### **IN THE DRAWINGS**

## **REMARKS**

FIG. 3

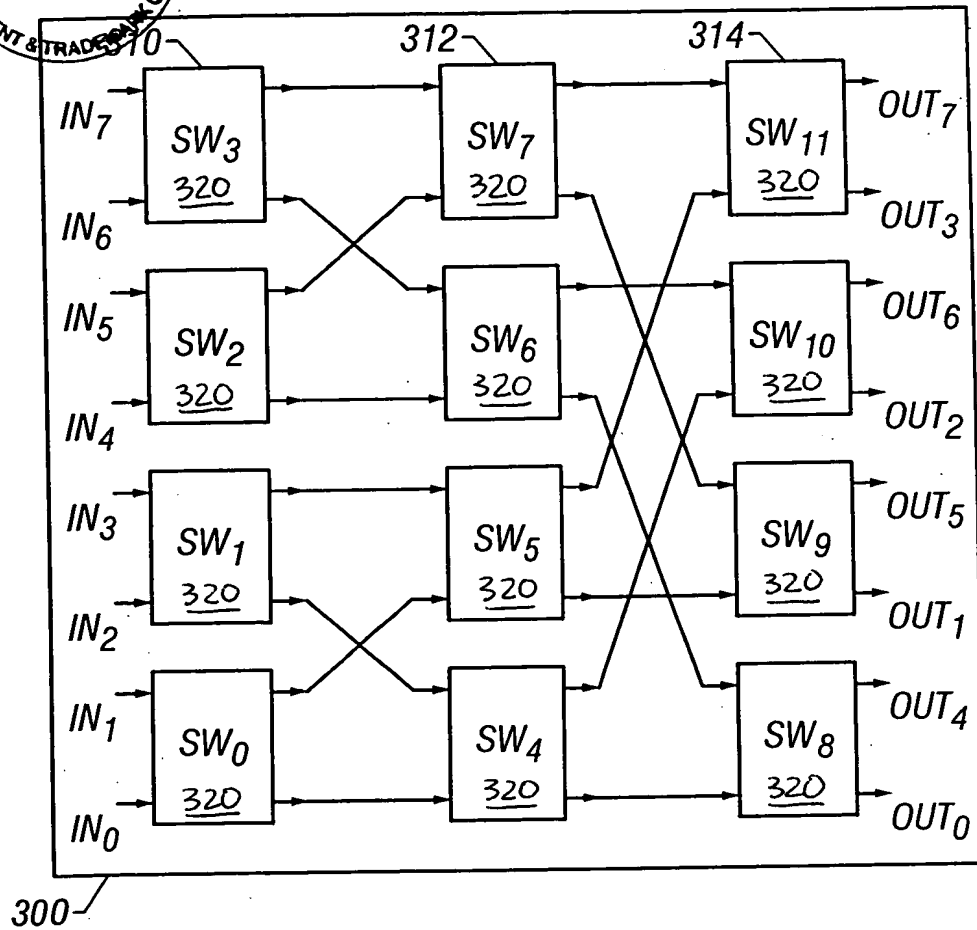
Please replace Drawing Sheet 2, including Fig. 3 and Fig. 4, with the attached Replacement Sheet, including amended Fig. 3 and original Fig. 4.

Applicant has amended Fig. 3 to identify each switching cell with a reference numeral 320. This amendment is supported by the specification in the paragraph beginning on page 3, line 12. Applicant has amended Fig. 5 to identify the first signal propagation path with a bracket and a reference numeral 580 and to identify the second signal propagation path with a bracket and a reference numeral 582. This amendment is supported, for example, by the paragraph beginning on page 9, line 21. Applicant submits that no new matter is introduced as a result of these amendments.

FIG. 5

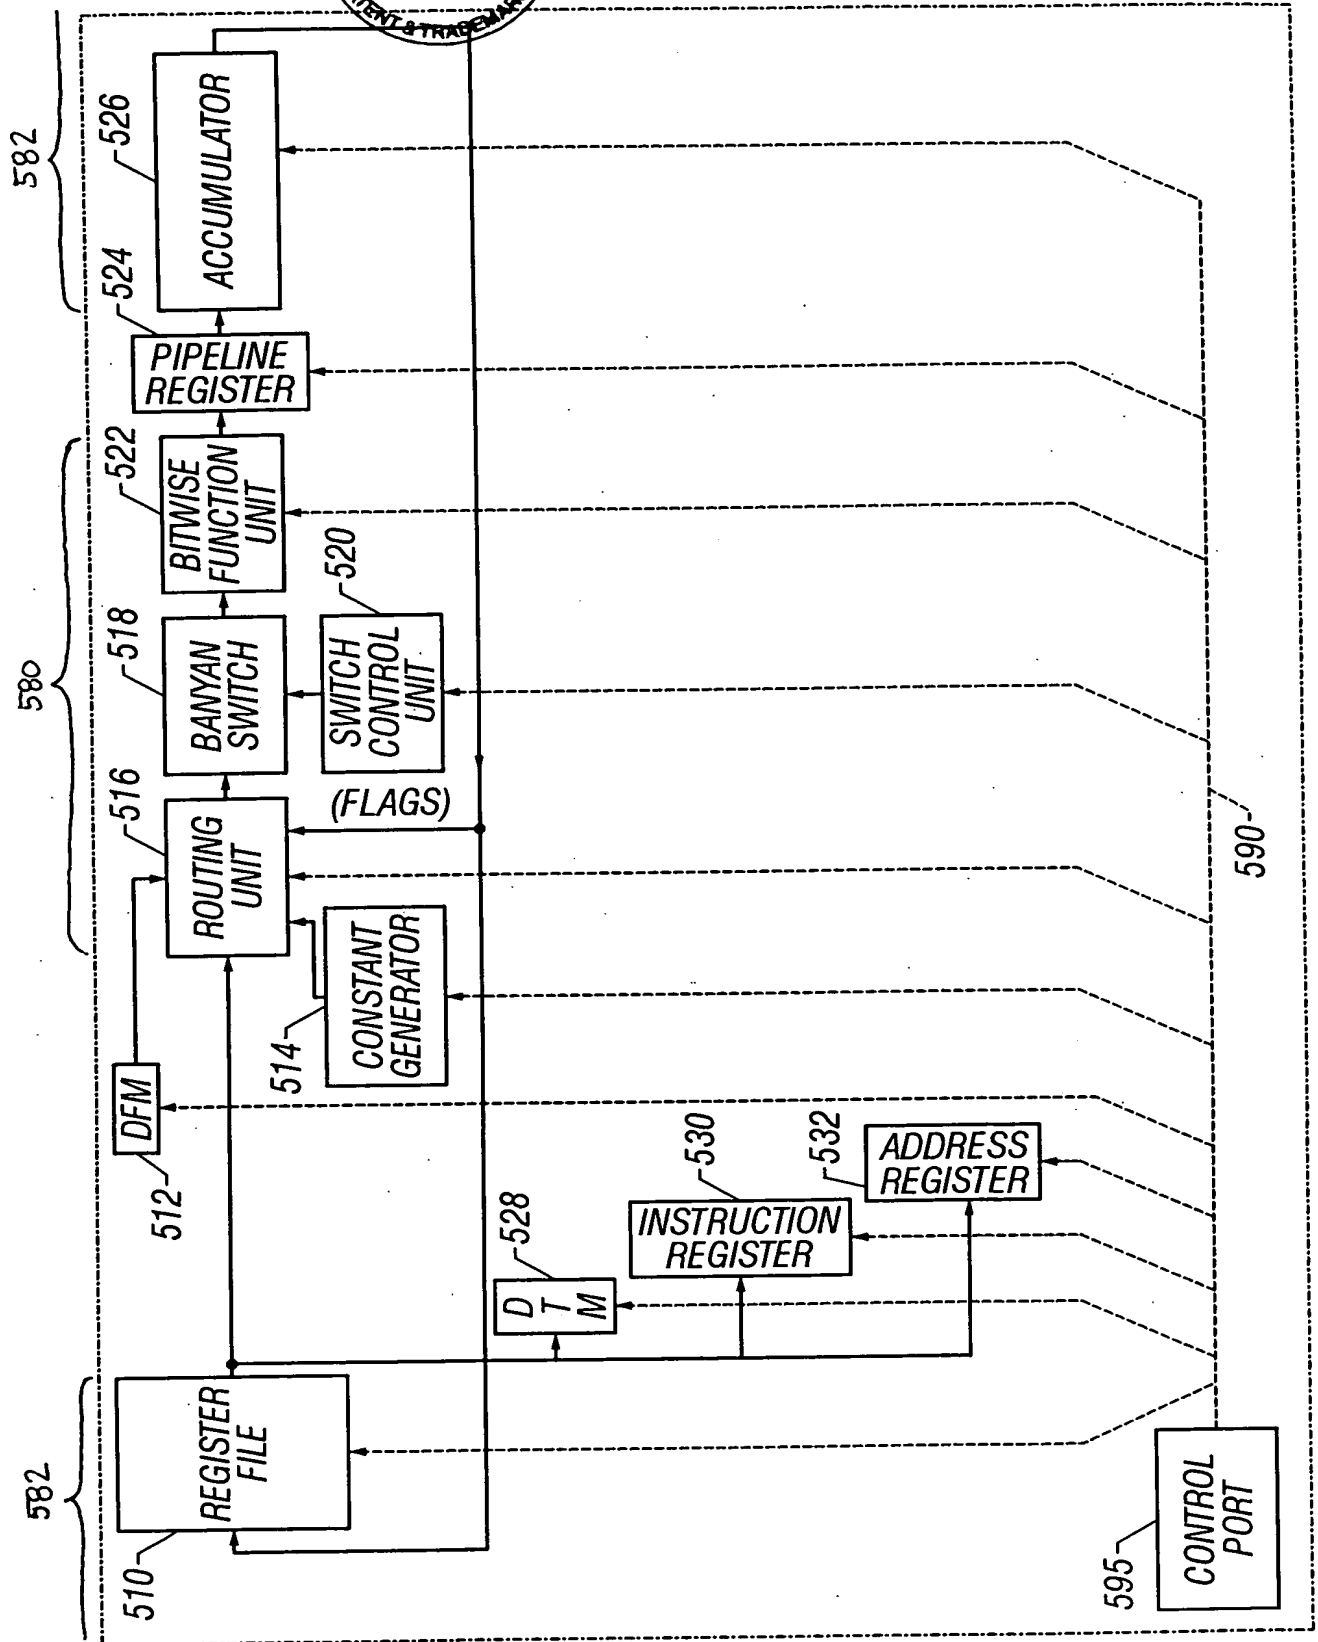
Please replace Drawing Sheet 3, including Fig. 5, with the attached Replacement Sheet, including amended Fig. 5.
